WESTLAKE VILLAGE

**SUBJECT: Addendum No. 1 - City of Westlake Village Community Park Project –
Phase IIB – Park Improvements**

The following additions and/or corrections shall become a part of the Contract Documents
and Specifications for the above-named project. **ALL PROPOSERS SHALL
ACKNOWLEDGE RECEIPT OF THIS ADDENDUM ON PAGE C-3A OF THEIR BID.**

PROJECT PLAN SHEET SD-1

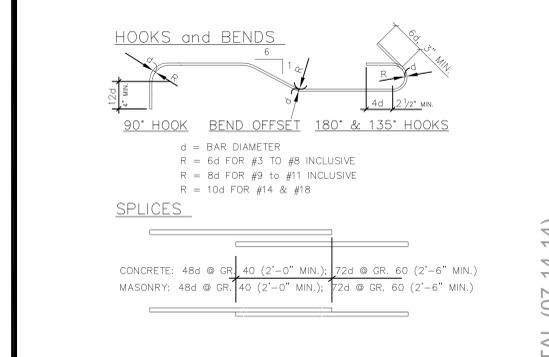
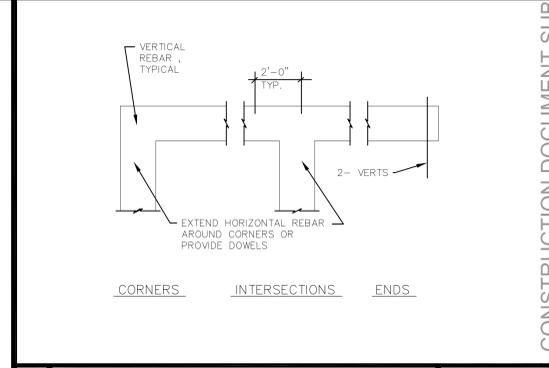
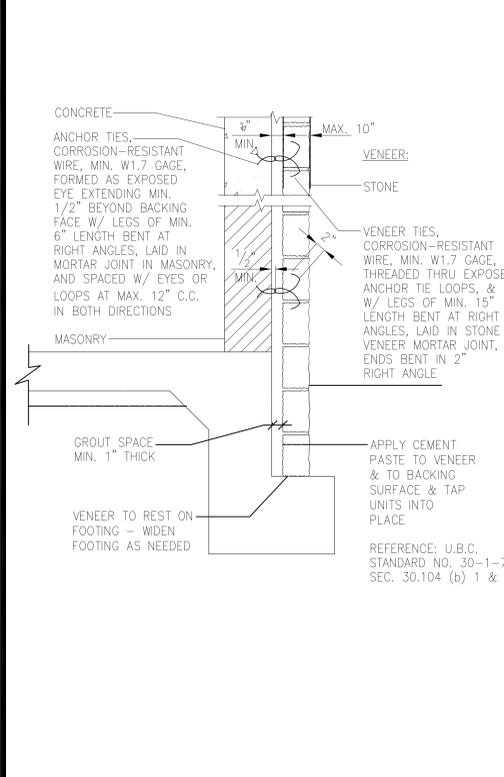
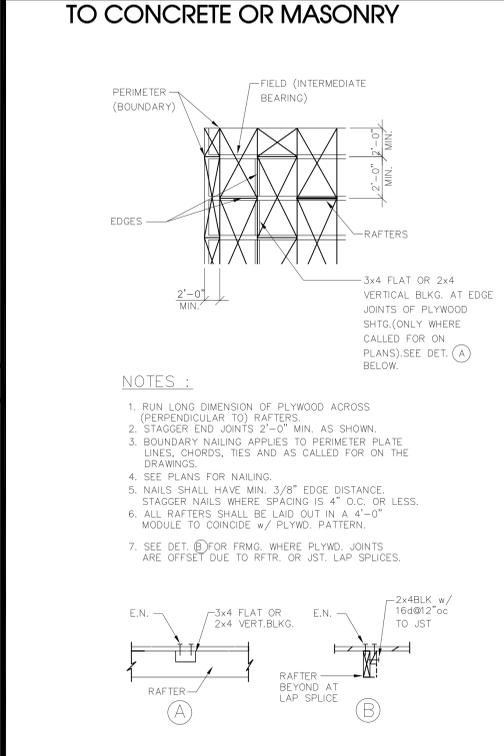
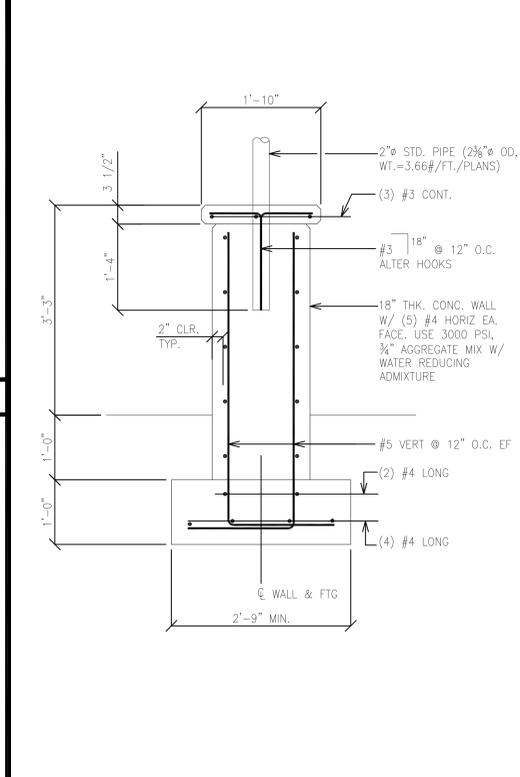
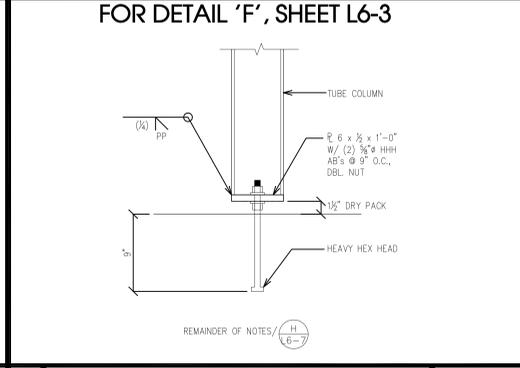
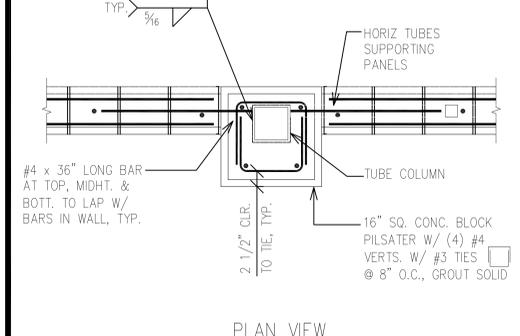
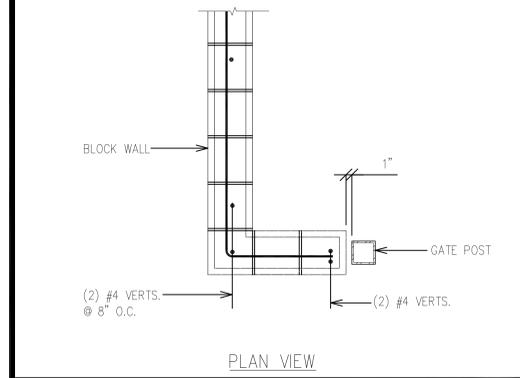
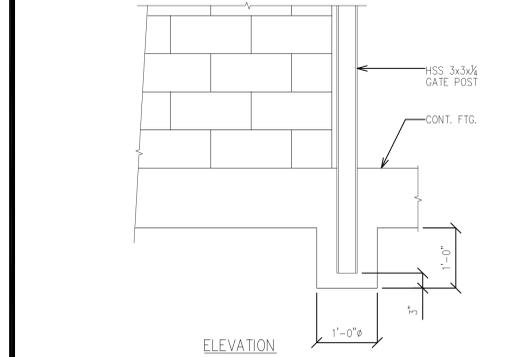
Please provide Sheet SD-1.

Please provide Sheet SD-1.

See Plan Sheet SD-1 attached

See Plan Sheet SD-1 attached

SHEET PG-03A
SHT 7 OF 92 SHTS

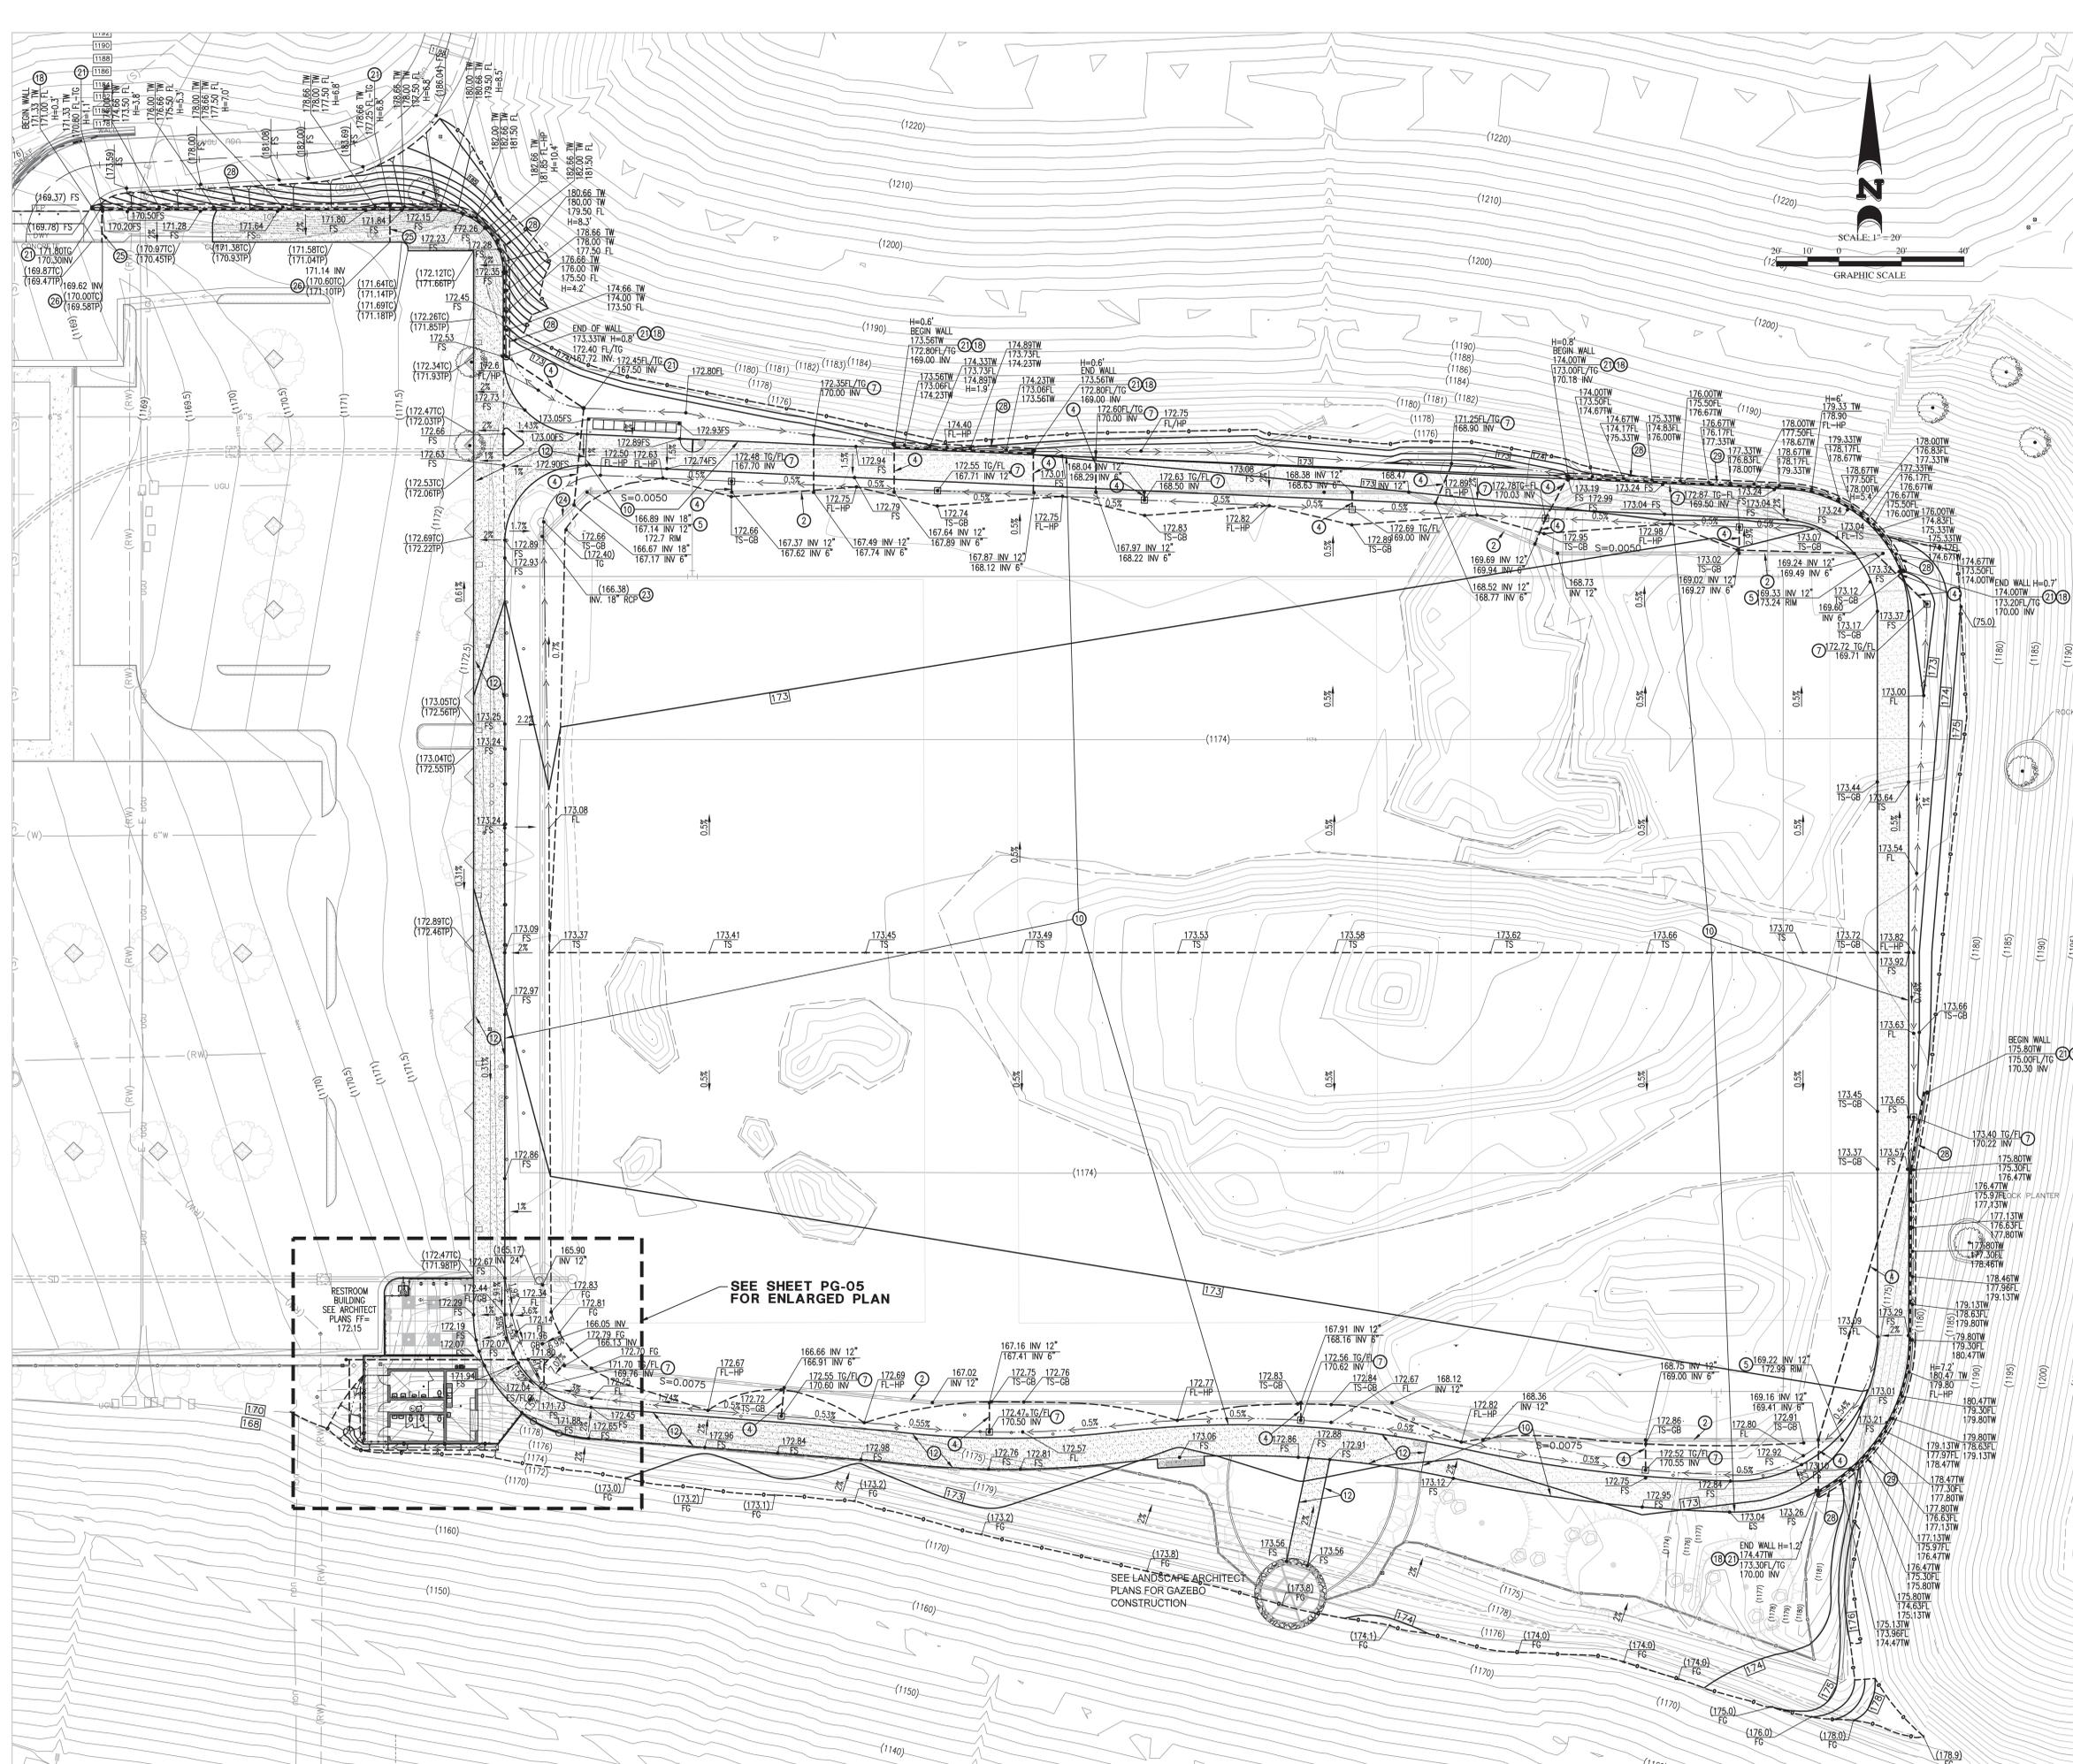
I cannot find anything in the plans regarding this. Please provide plan sheets necessary to obtain pricing and/or elaborate on what is expected of Contractor in the scope of this line item.

Refer to the enclosed Phase 2A Plans (PG-01, PG-04, PG-05, &PG-07). The work shown on these plans has been installed. Contractors shall then be required to make any Storm Drain connections and stubouts necessary to complete the Phase 2B Park Improvements.

MATCH LINE SEE SHEET WU-3

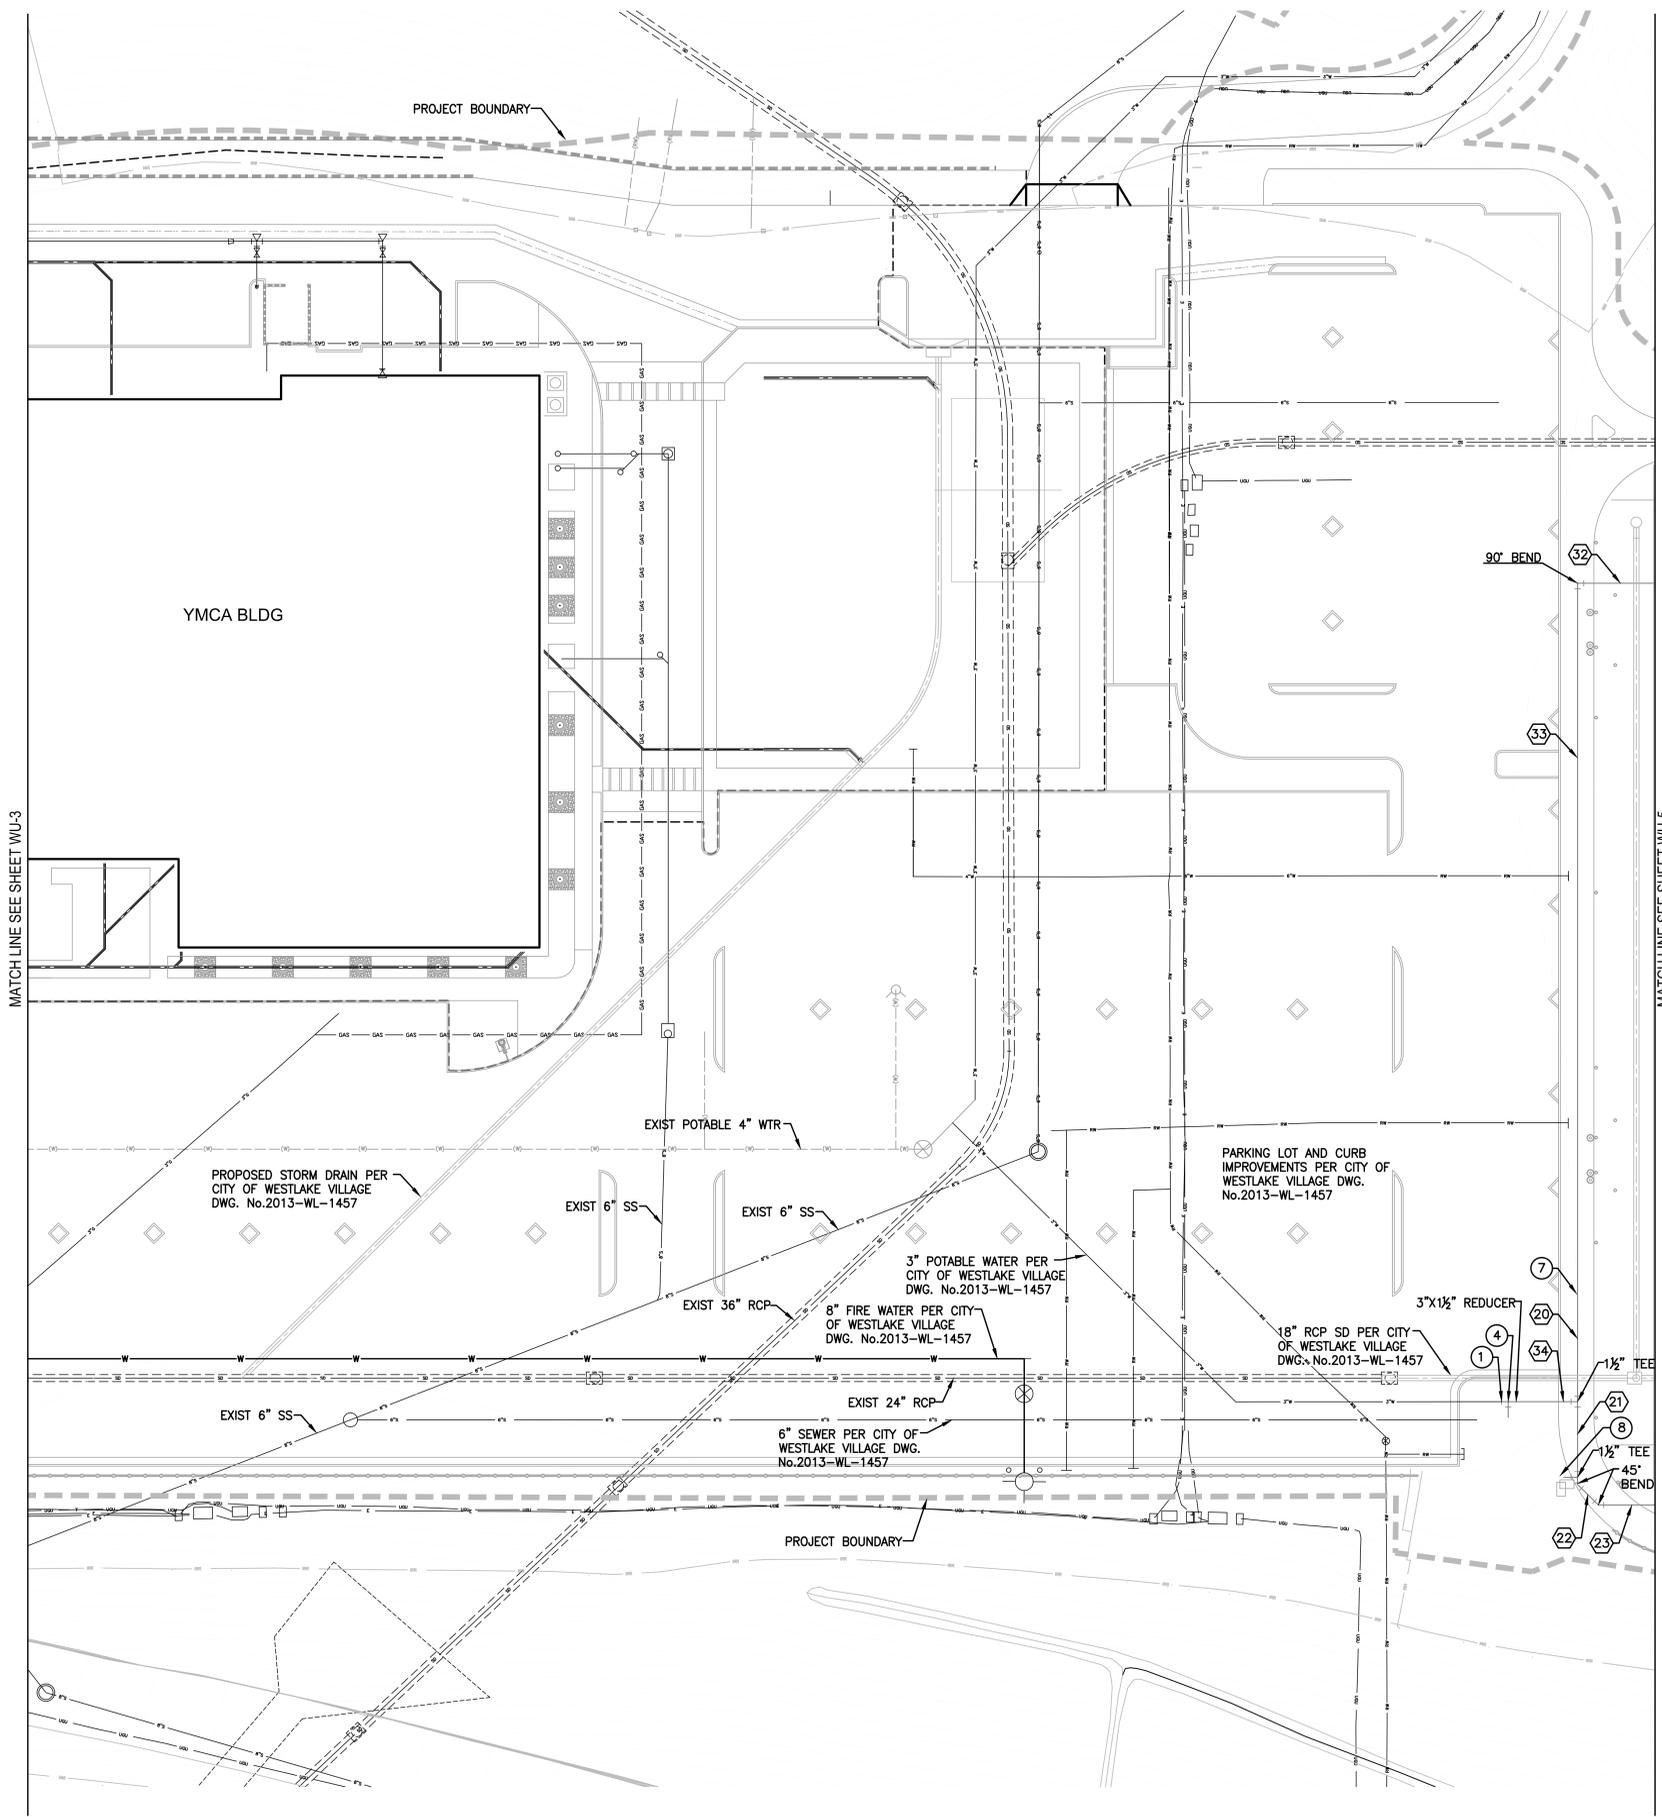
How far is the existing sewer planned point of connection from the nearest edge of the restroom building?

How far is the existing water planned point of connection from the nearest edge of the restroom building?

Sewer POC is +/- 30-feet eastward. See sheet WU-4 of the Phase 2A utility locations for existing utility information.

Water POC is +/- 30-feet eastward. See sheet WU-4 of the Phase 2A utility locations for existing utility information.
